**PLANNED UNIT DEVELOPMENT &
SUBDIVISION STAFF REPORT****Date: June 5, 2008**

<u>NAME</u>	Longleaf Gates Subdivision
<u>SUBDIVISION NAME</u>	Longleaf Gates Subdivision
<u>LOCATION</u>	North side of Girby Road 1800'± West of Rue Preserve, and extending Northwest to Lloyds Lane.
<u>CITY COUNCIL DISTRICT</u>	District 6
<u>PRESENT ZONING</u>	R-2, Two-Family Residential District
<u>AREA OF PROPERTY</u>	163 Lot / 84.2 ± Acres
<u>CONTEMPLATED USE</u>	Planned Unit Development Approval to amend a previously approved Planned Unit Development to allow a private street, gated subdivision, and a public street subdivision, both with reduced lot sizes, reduced front yard and side yard setbacks, and increased site coverage, and Subdivision approval to create 163-lots.
<u>TIME SCHEDULE FOR DEVELOPMENT</u>	<i>Phase One:</i> Roads under construction, with home construction anticipated to begin by October 2008; <i>Phase Two:</i> schedule to be determined after Phase One is completed.
<u>ENGINEERING COMMENTS</u>	Show Minimum Finished Floor Elevation (FFE) on plans and plat for all lots located within the X-Shaded and AE Flood Zones. No fill allowed within a special flood hazard area without providing

SITE PLAN

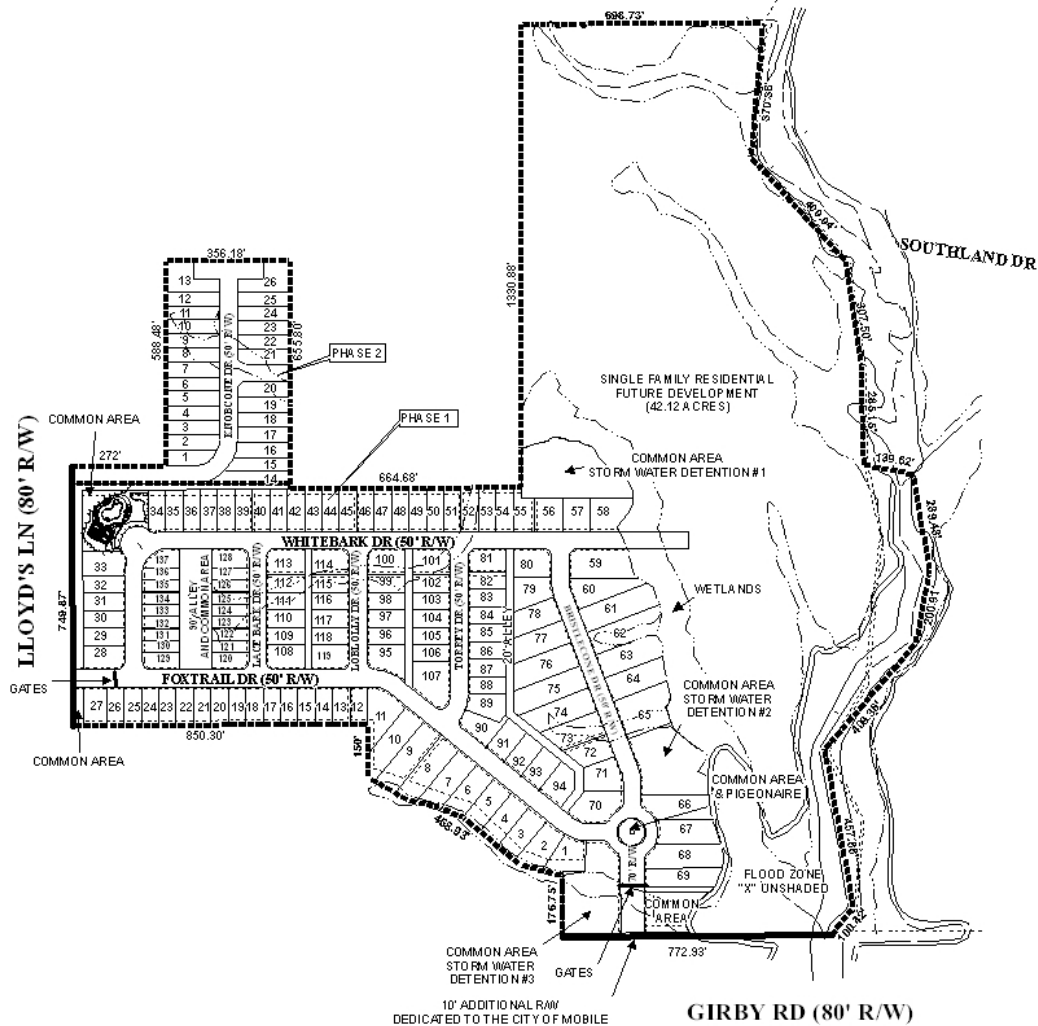
It appears that the plat and site plan do not include the full extent of the parcels set aside for “future development,” specifically an area of land along the creek along the Northeastern boundary of the site. The drawings should be revised to account for the entirety of all parcels. It

Access management is a concern due to the reduced size of the lots and the proximity to a proposed major street. A note should be placed on the site plan and plat stating that direct access to Girby Road and Lloyd’s Lane is denied for all lots and common areas, and each lot (and common area if required for maintenance purposes) should be limited to one curb-cut each onto any street (no curb-cut limit onto alleys), with the size, design and location to be approved by Traffic Engineering and comply with AASHTO standards.

Approximately 3.6 acres of common areas are depicted on the site plan. Some of the common areas include storm water detention facilities which will be shared between the Phase One and Phase Two developments. A “pigeonaire/guard house” is also proposed at the center of a traffic circle. A 1,500 square foot club house and 1,555 square foot pool are depicted in the Northwest corner of Phase One (previously located in the Northeast corner). Off-street parking will be provided for the clubhouse, however the site plan appears to indicate that it may be parking that backs into the private-street right-of-way. A note should be placed on the site plan and plat stating that maintenance of the common areas shall be the responsibility of the property owners.

There is also a note on the site plan and plat stating that “all road right of way and alley right of way areas are privately owned and operated.” This statement, as written, would include Phase Two. *In fact, nothing in the documentation submitted with the application states that the roads in Phase Two are public.* The site plan and plat should be revised to clearly indicate which roads are public and which are private.

The site adjoins a creek and as such the area may be considered environmentally sensitive; thus the approval of all applicable federal, state and local agencies would be required. Additionally, there are wetlands on the site, which encroaches into some lots; and while reduced lot widths and sizes are allowed, the applicant should submit documentation prior to the recording of the final plat, which illustrates that there is adequate buildable area for those lots containing wetlands.

Due to the size of the proposed development, it is requested that the applicant revise the plat and site plan to provide the size of each lot in square feet on the plat, either as a table or as a label for each individual lot.

- 1) Revision of the site plan to encompass the entirety of the parcels associated with the “future development” area;
- 2) Submission of applications to correct split-zoning conditions in the “future development” area in conjunction with the other future applications that will be required for the area;

- 3) Revision of the site plan to eliminate any parking for the clubhouse that may require backing into the street right-of-way;
- 4) Placement of a note on the site plan stating that maintenance of the common areas is the responsibility of the homeowners (association);

- 5) Placement of a note on the site plan identifying which streets are private (for both phases), and that they are privately maintained and not dedicated to the public;

- 6) Placement of a note on the site plan stating that additional street-stub connections will be required in the “future development area” – to adjacent public streets and landlocked properties (for emergency access only);

- 7) Placement of a note on the site plan and plat stating that direct access to Girby Road and Lloyd’s Lane is denied for all lots and common areas, and each lot (and common area if required for maintenance purposes) should be limited to one curb-cut each, and each alley is limited to one curb-cut on each end, with the size, design and location to be approved by Traffic Engineering and comply with AASHTO standards;

- 12) Labeling of all lots with size in square feet, or provision of a table with the lot size information on the plat;
- 13) Revision of the site plan and plat to also include site coverage information for the lots;
